UNITED STATES PATENT AND TRADEMARK OFFICE

10/534,493

Office Action Summary	Application No. 10/534,493	Applicant(s) BETTINZOLI, ANGELO	
	Examiner ANDREW ST CLAIR	Art Unit 3749

DETAILED ACTION

Modified Figure 2 of De'Longhi

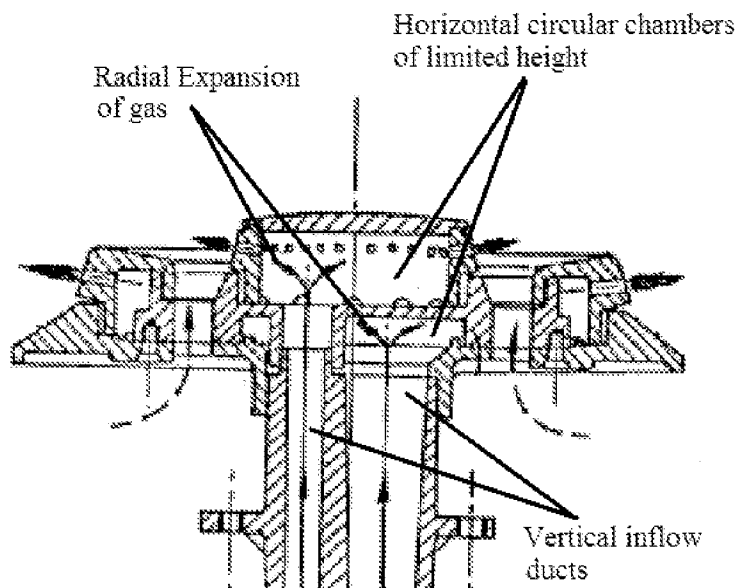
The bulk of Applicant's arguments are directed at the difference between a radial Venturi effect and a axial Venturi effect. While Examiner appreciates that this may be what Applicant intended by the claim language, Examiner disagrees that the claims as written are so limited; Applicant's interpretation, while reasonable, is not the *only* reasonable interpretation of the claim language. The tube 11 of De'Longhi is considered to provide a radial Venturi effect in that it provides a Venturi effect by means of a tube of varying radius.

Moreover, even if Examiner accepted what appears to be an unduly narrow interpretation of the claim language, De'Longhi nevertheless discloses this functionality. That is to say that De'Longhi discloses "a horizontal circular chamber of limited height immediately downstream of the vertical inflow duct." (Applicant's arguments, page 10.) See the figure below.

Applicant's only other argument is "[In De'Longhi] primary air is sucked within the burner by the axial Venturi tube 10, 11 from below the cooking hob." Applicant characterizes the air passing through the tubes 10 and 11 as primary air; as made clear in the non-final rejection the air inlets 18 are considered to anticipate this claim limitation in that they are above the cooking hob and allow for passage of air that can be characterized as "primary air."
